## SERVICE INFORMATION NO. SI 40-057/1

All DA 40 & DA 40 F aircraft equipped with GARMIN G1000 system.

**Service Alert: 070801-01**

#### **REVISION B: Revised Affected Products and Aircraft Section**

**Figure 1. Engine System Display (Typical)**

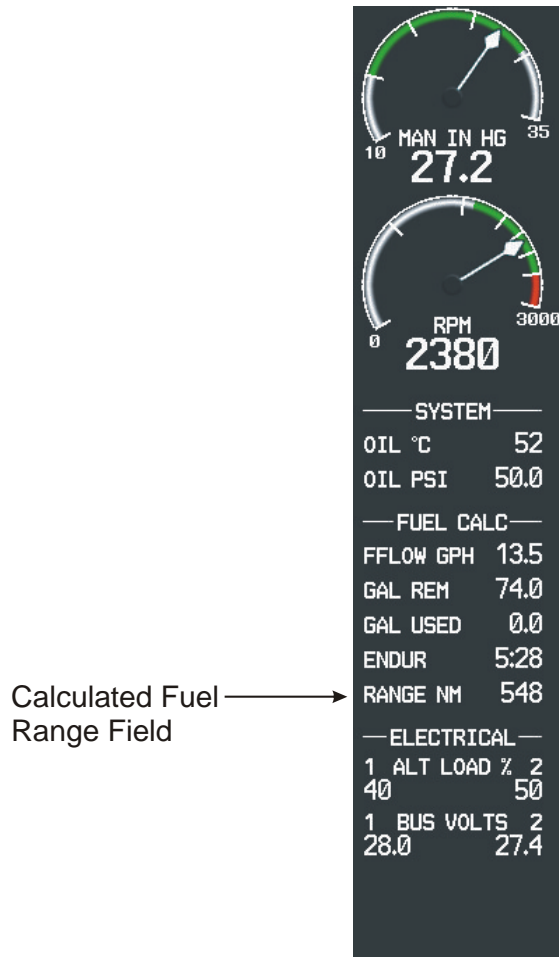
Affected aircraft use a Calculated Fuel Range Field (Figure 1) that works correctly only when the Distance/Speed Display Unit Field on the AUX - System Setup Page is set to NAUTICAL (NM, KT) (Figure 2).

When the Distance/Speed setting on the AUX System Setup Page is changed to METRIC (KM, KPH), the Calculated Fuel Range Field on the Engine System Display is inaccurate. This may cause the pilot to mistakenly believe he can fly farther than is possible on the remaining fuel.

GDU software V8.20 or later incorporates a change correcting the issue. Until GDU software V8.20 or later is installed, the pilot should select NAUTICAL (NM, KT) Display Units for Distance/Speed on the AUX System Setup Page (Figure 2). Instructions on changing the Distance/Speed Units are in the Pilot's Guide and Cockpit Reference Guide for the aircraft listed in this Service Alert.
